P 515259-B

## ON-SITE SEWAGE DISPOSAL SYSTEM HOWARD COUNTY HEALTH DEPARTMENT BUREAU OF ENVIRONMENTAL HEALTH

SUBDIVISION: Estates @ Sandhill LOT NUMBER: 7

ADDRESS: 12025 Sand Hill Manor Drive PROPERTY OWNER: Oakhill Properties

NOT TO SCALE

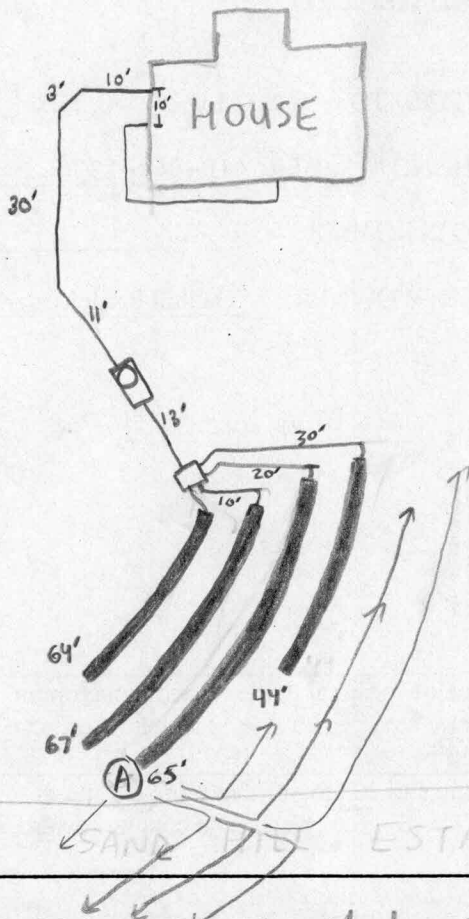
PRE-CONSTRUCTION INSPECTION: 6/21/01 - SDA STAKED, PROCEED W/ GRAVITY SYSTEM AT 4'-6' OR PUMP AT 3'-5', - (SRK)

INSPECTION COMMENTS: 6/28/01 - OK TO COVER ALL WORK, 1ST REPAIR SHOULD INVOLVE SETTING A NEW D. BOX IN LOCATION (A) AND RUN TRENCHES ON CONTOUR IN BOTH DIRECTIONS AS ARROWS INDICATE, NEW SOLID SCH. 40 COULD BE RUN FROM SEPTIC TANK OUTLET TO NEW D. BOX GOING THRU/OVER EX. TRENCHES, INLET TO BE 4' AND BOTTOM 6' - (SRK)
